A Subsidiary of **FREIGHTLINER**
LLC

Recall 07V-137

INSTRUCTION SHEET #TBB 85490083

SUBJECT: BRAKE PEDAL INTERFERENCE

Figure 1

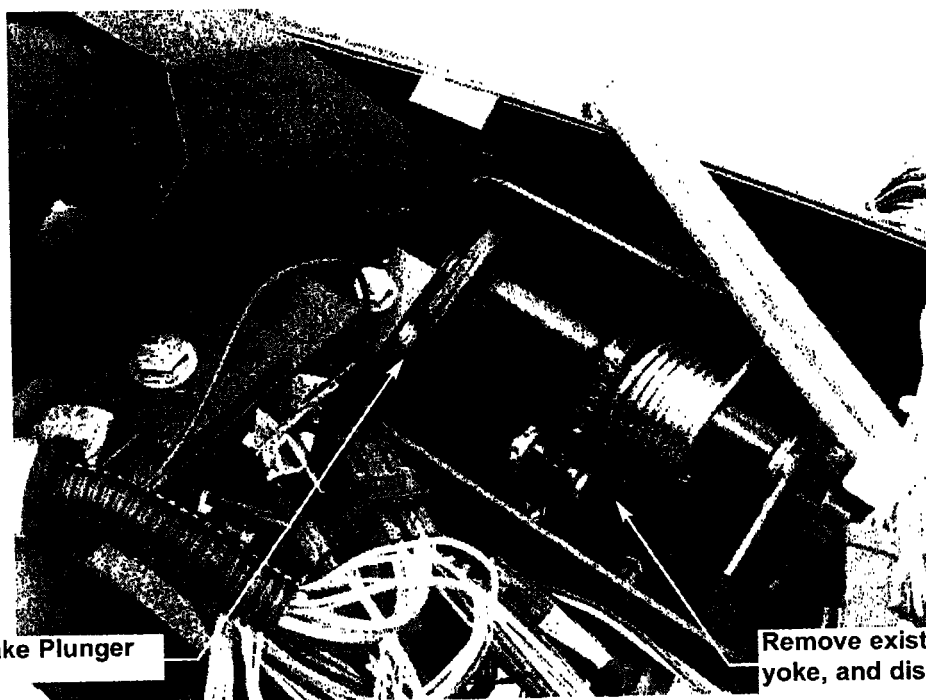
1. Secure vehicle with wheel chocks and disconnect batteries.
2. Locate the brake plunger and yoke assembly. **Figure 1**

Figure 2

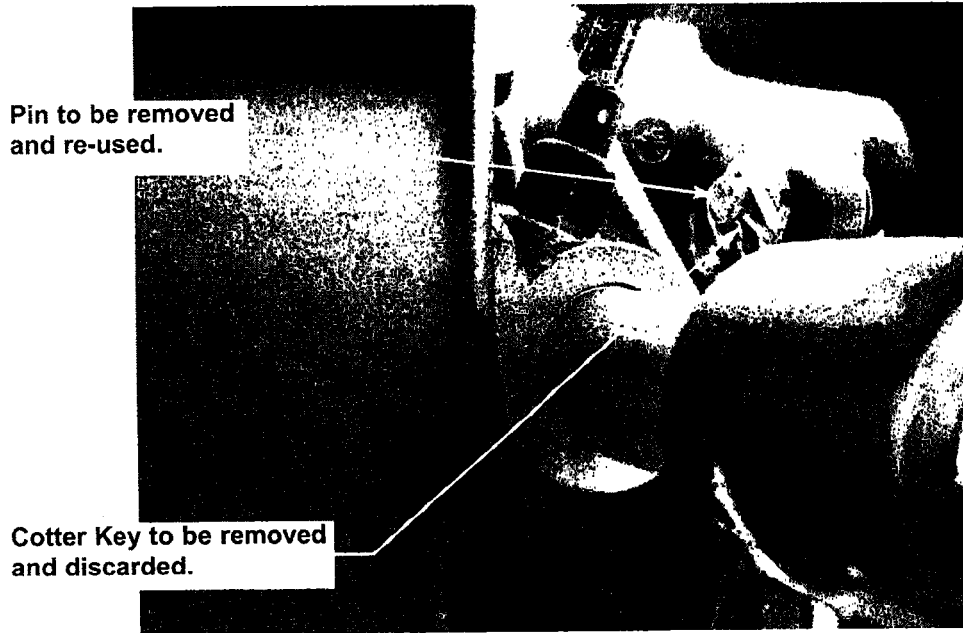
3. Push up on brake pedal and remove existing yoke.
 - a. Remove cotter key and pin and discard. **Figure 2**

Figure 3

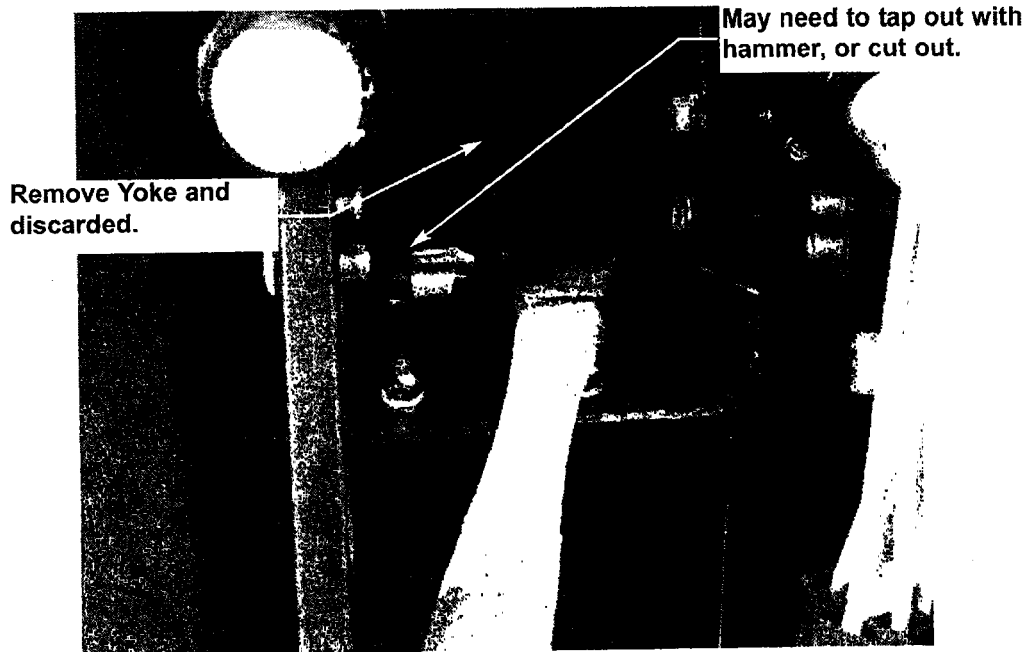
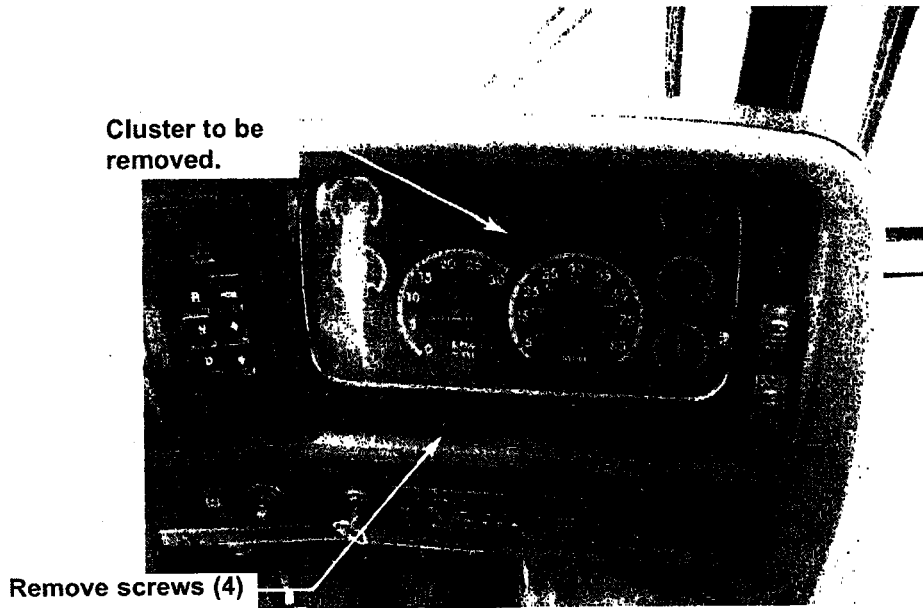
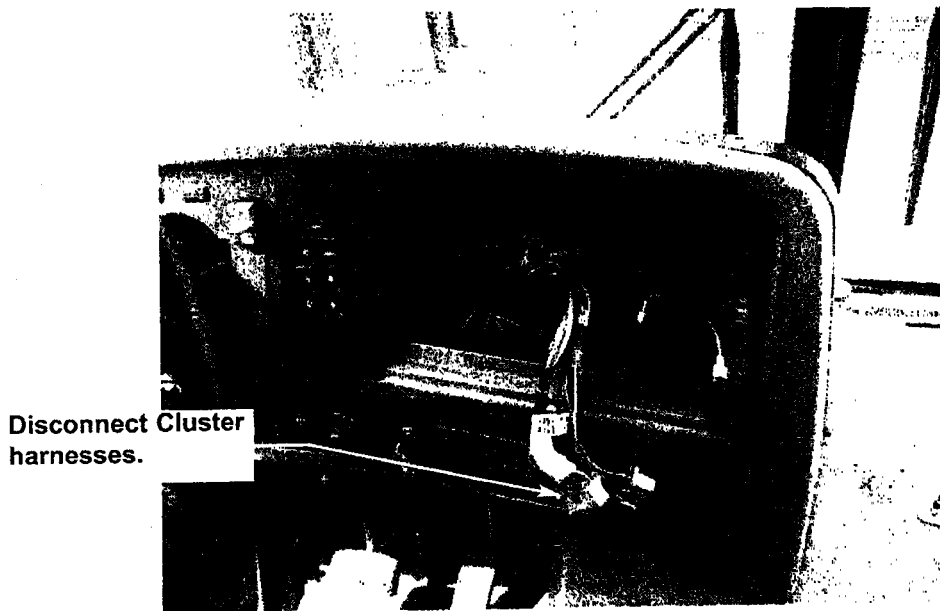
- b. Remove yoke. You may need to cut, or tap it out with a hammer. Figure 3

4. Install new Yoke, #TBB 62170586
 - a. Insert pin and new Cotter Key, #TBB 61370955.
5. Remove electrical ICU cluster assembly and unplug. **Figure 4**
 - a. Note: Electrical connections.
 - b. Remove four (4) screws.

Figure 6

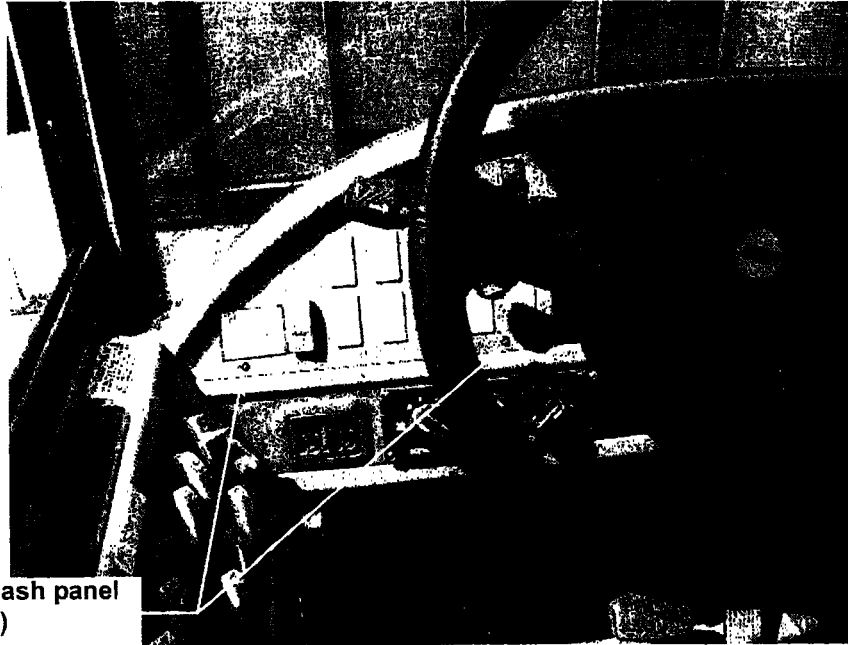
6. Remove screws securing dash panel. Retain screws to be reinstalled. **Figure 6**

Figure 7

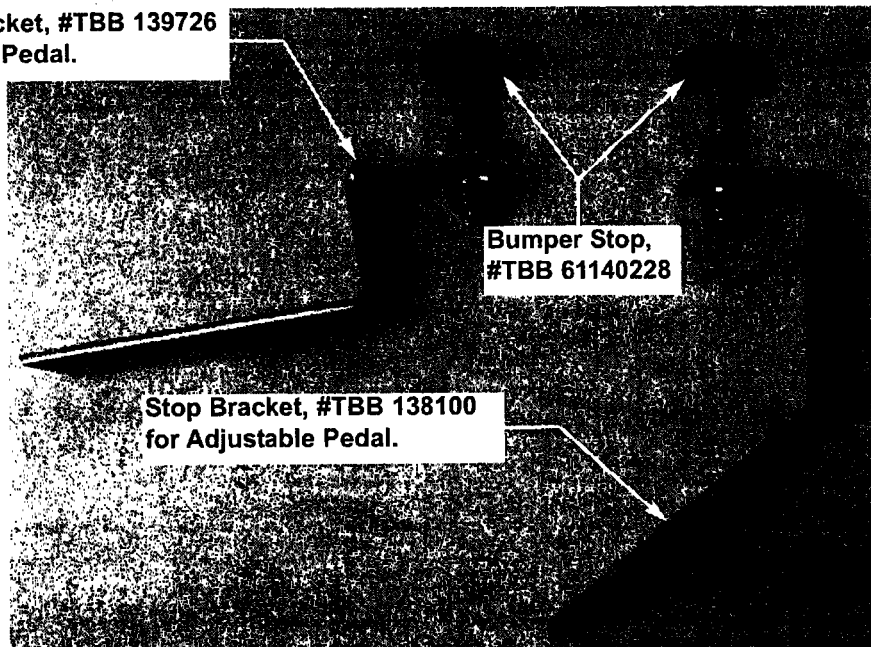
7. Locate new Brake Pedal Stop Mount Assembly, #TBB 138100 for Adjustable Pedal or #TBB 139726 for Fixed Pedal. Clamp in place. **Figure 7**

**Stop Bracket, #TBB 139726
for Fixed Pedal.**

Figure 8

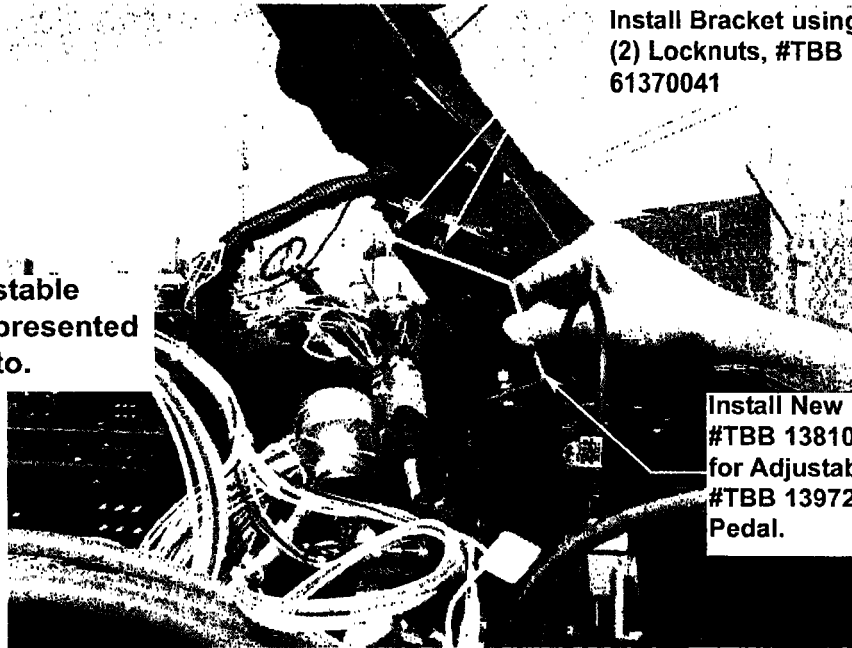
8. Remove existing nuts on column. **Figure 8**
9. Attach bracket with two (2) new Locknut, #TBB 61370041.

Note: Adjustable Pedal is represented in this photo.

10. Adjust brake pedal bumper for 1/8" minimum travel before bumper contacts bracket.
 - a. Note: This should give you .063 - .250 free travel before brake plunger contacts piston.
11. Re-install dash panel and gage cluster
